## **ADDENDUM NUMBER 1**

**PROJECT:** CAST-IN-PLACE CONCRETE

**OWNER:** UA RICH MOUNTAIN

## AUTOMOTIVE BUILDING

**A1.01 FLOOR PLAN:** *Refer to attached revised drawing*

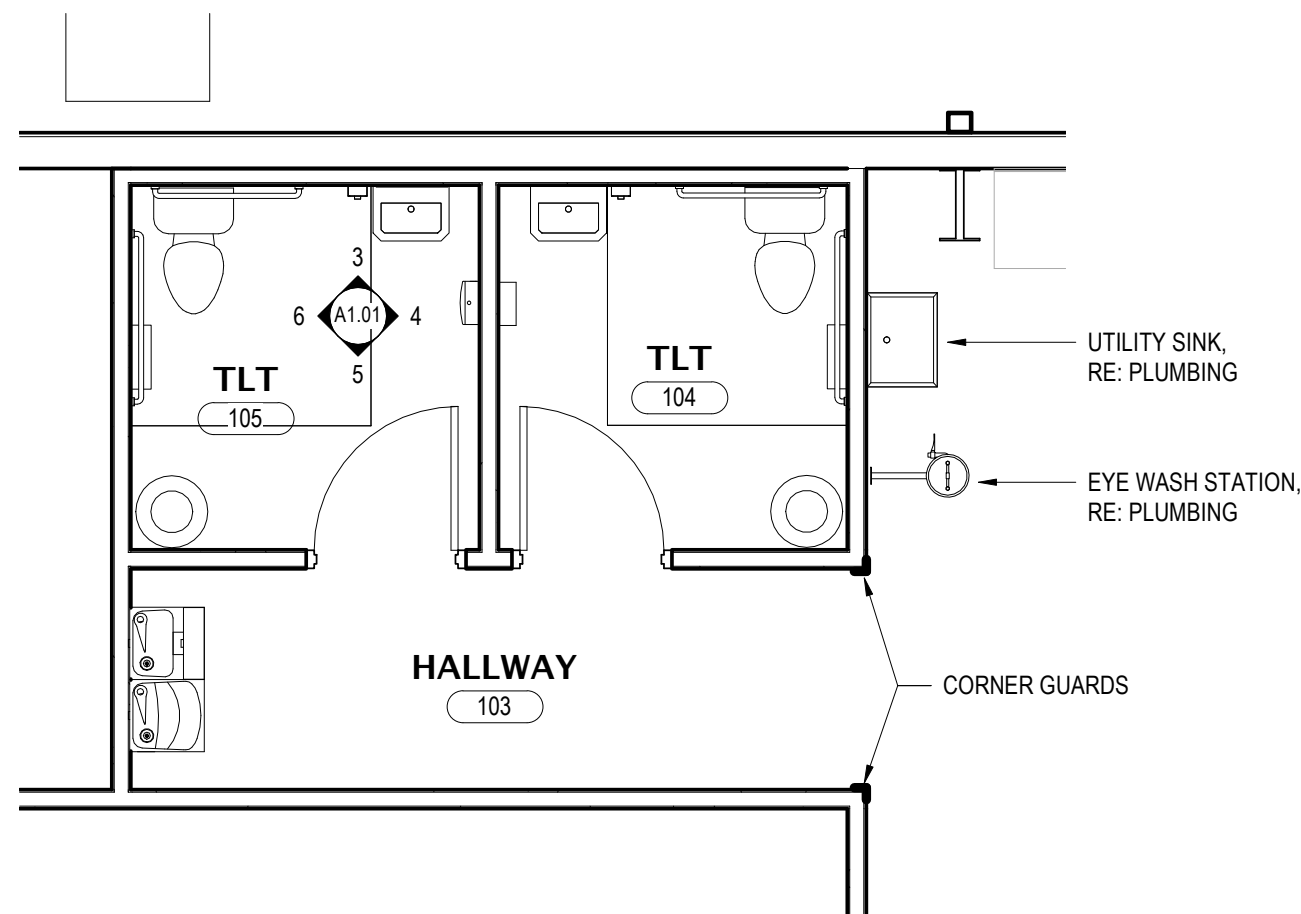
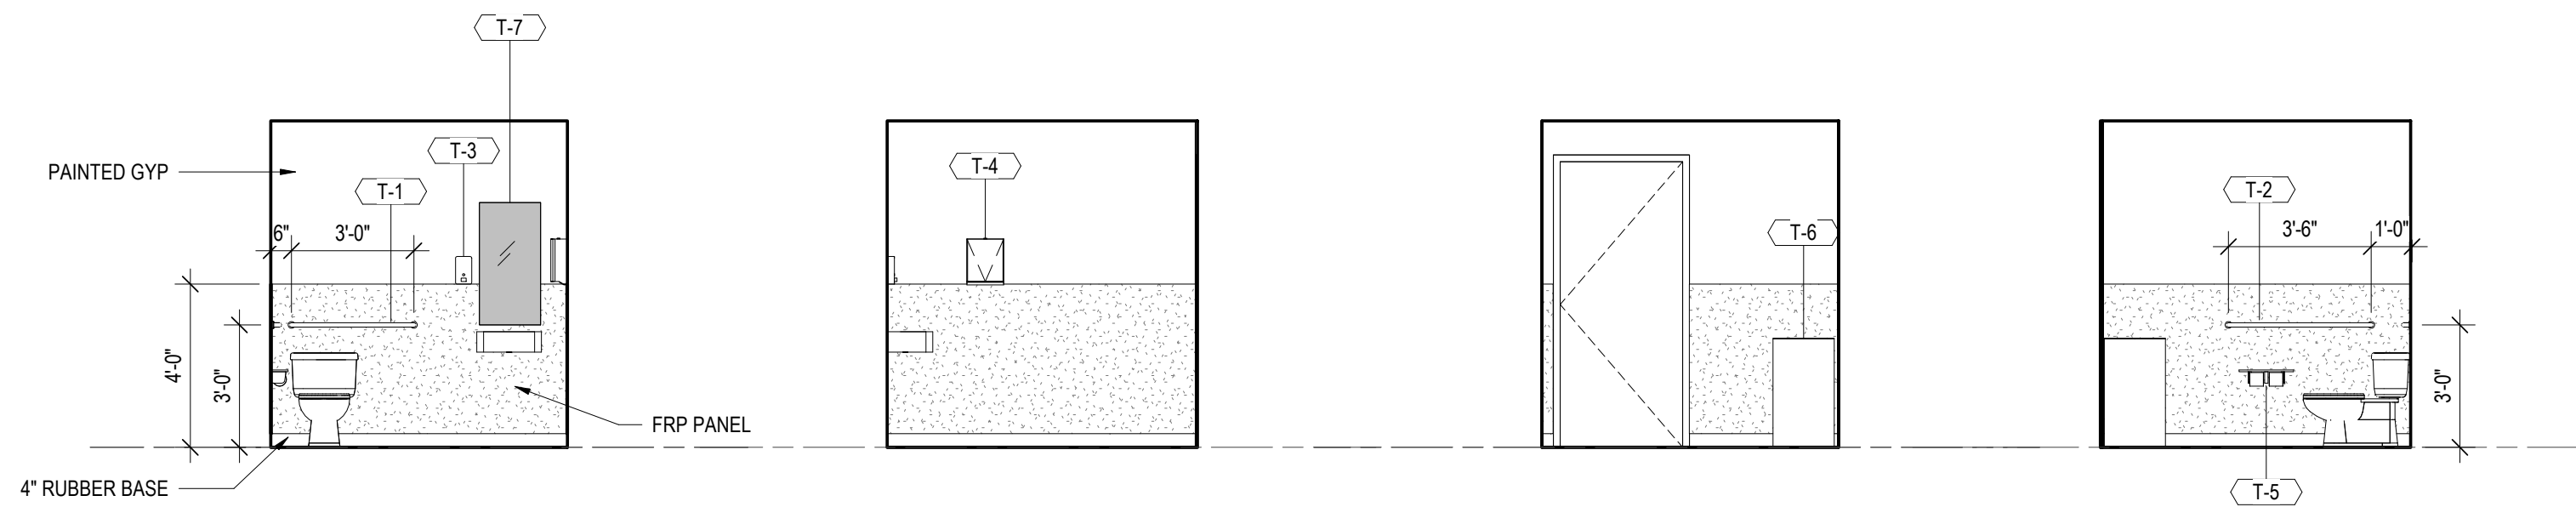
1. Added note detailing exterior concrete construction
2. Added saw cut joint layout for exterior concrete
